**TEXAS UTILITIES GENERATING CO.
COMANCHE PEAK S. E. S.**

**ANALYSIS OF THE CLOGGING OF ECCS
SUMP TRASH RACKS BY DEBRIS AND
PAINT PEELS FOLLOWING AN ACCIDENT**

ERRATA
FOR EBASCO REPORTS

June 1, 1984

Figure 6

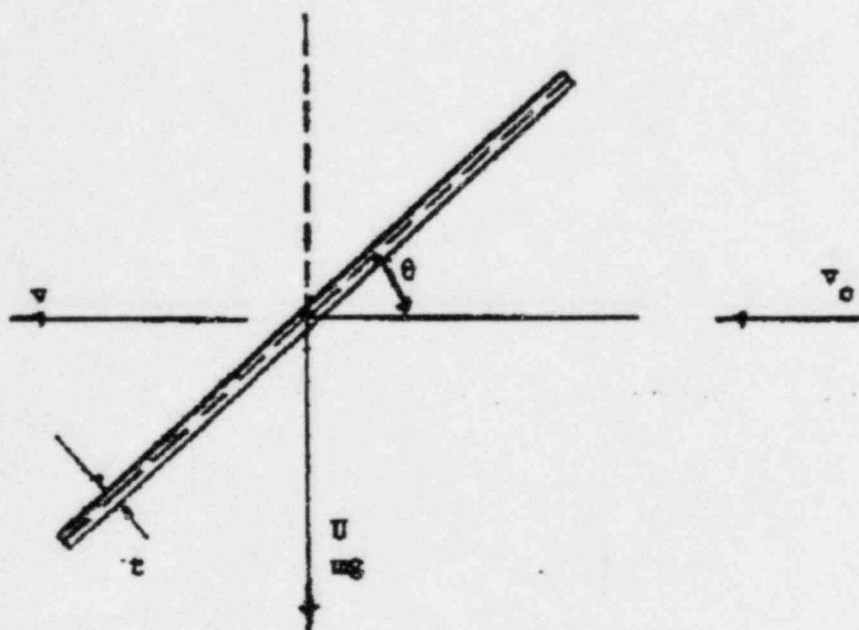
These equations (1) and (2) are numerically solved for paint peel horizontal and vertical terminal velocities. The results have been plotted on Figure 7.

An angle of zero would result in the longest vertical travel time. The furthest horizontal travel occurs at the angle for which the value of the multiplication of the horizontal velocity and the vertical travel time is the largest. As seen from Figure 7, the longest travel time occurs at a small angle. However, the equations used to model the paint peel fall are inappropriate at angles near zero and ninety degrees since boundary layer effects on drag have been ignored in the equations. Consequently, results at angles greater than 85° and less than 5° are not considered to be representative of actual conditions. Despite these assumption problems, the average horizontal travel distance for any paint peel can be calculated to fall between 22 and 24 feet using the information presented in Figure 7.

Figure 6 illustrates a paint peel at an angle θ to the horizontal moving under water. The weight mg acts vertically downwards. The peel would fall down under the influence of mg opposed by drag and aerofoil type of lift forces. The equations of motion in the vertical and horizontal directions respectively are:

$$m \frac{du}{dt} = mg - \frac{C_D u}{2} \rho_w A \cos \theta U^2 \quad (1)$$

$$m \frac{dv}{dt} = \frac{C_L u}{2} A \cos \theta U^2 - \frac{C_{Dv}}{2} \rho_w A \sin \theta (v - v_0) |v - v_0| \quad (2)$$
